**TAFE NSW WESTERN SYDNEY CONSTRUCTION HUB**

**BUILDING CODE OF AUSTRALIA 2019 Amendment 1  
SCHEMATIC DESIGN REVIEW**

**JANUARY 2021**

Report prepared for	Gray Puksand 1/156 Clarence Street Sydney NSW 2000  Attention: Barry Hackett
Report prepared by	Metro Building Consultancy Suite 102, 12 Mount Street, North Sydney NSW 2060  Consultant: Sean Moore
Report reference	20243R03 BCA
Job number	20243
Date	22 <sup>nd</sup> January 2021

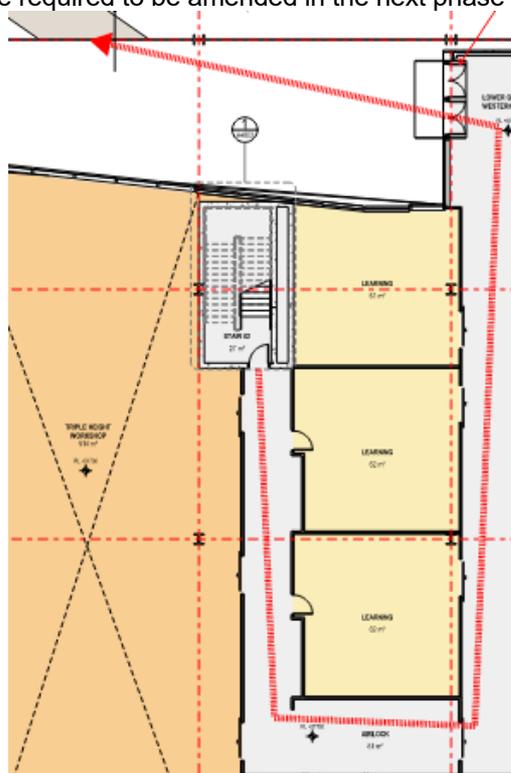
Architect to note – Stair 2 currently discharges within the building and does not discharge into a fire-isolated passageway. The point of discharge is furthermore not open for more than 2/3 of its perimeter and travel to road or open space is more than 20m. Plans are required to be amended in the next phase of design.

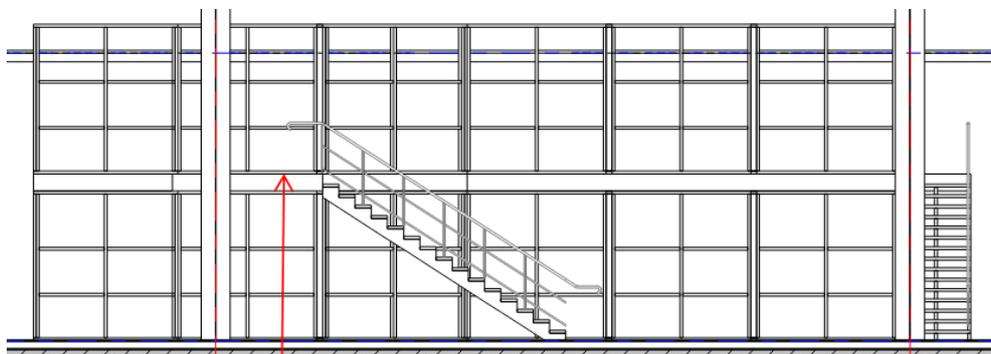
It is unclear as to whether there is a suitable barrier provided to the mezzanine level as shown on the Architectural Documentation. Architect and client to confirm what the mezzanine area is proposed to be used for.

Where the mezzanine is used for general access a barrier is required to be provided along the outside landing and to the stair complying with BCA Clause D2.16 and Table D2.16a. Note that where this is the case, the balustrade serving these stairs must not permit any opening bigger than 124mm. The current detail will not comply.

Client to confirm the proposed use of this mezzanine and the Architect to amend the plans accordingly.

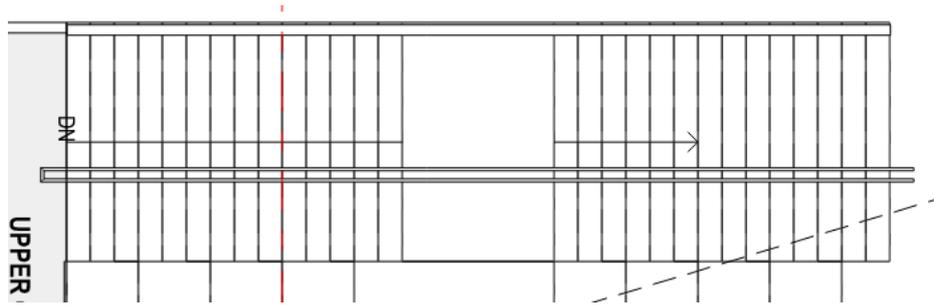
Architect to note that as the general circulation stair is required to be accessible, handrails are required to be provided to both sides of the stair in lieu of the middle.

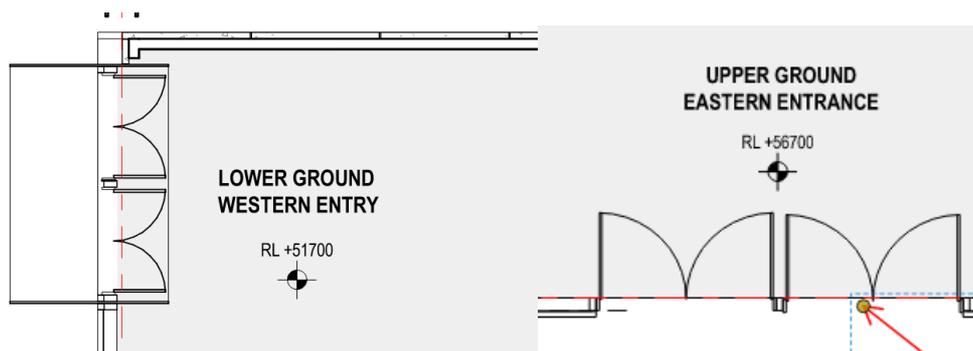
Architect to note that the lower ground Western Entry and the upper ground Eastern entrance are required to be exits and must swing in the direction of egress. Compliance readily achievable and to be amended in the next phase of design documentation.

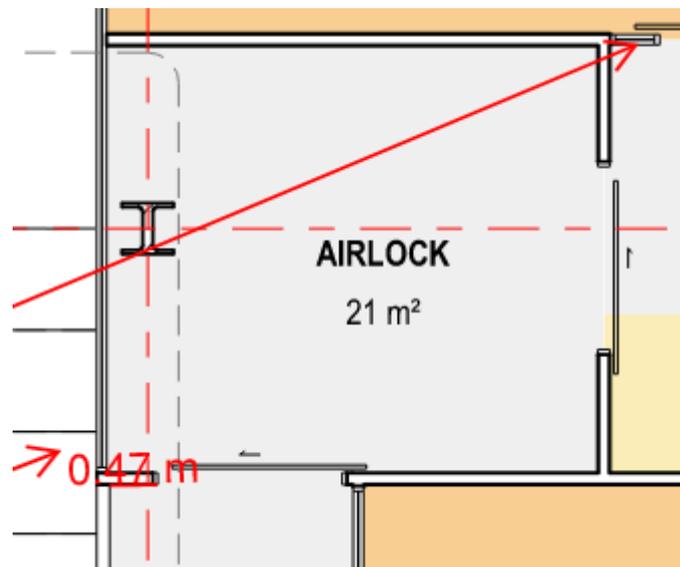
Latchside clearance to the general circulation sliding doors adjacent to the Electrical Wiring room 1 lacks sufficient latchside clearance (470mm in lieu of 530mm). Architect to amend plans to comply.
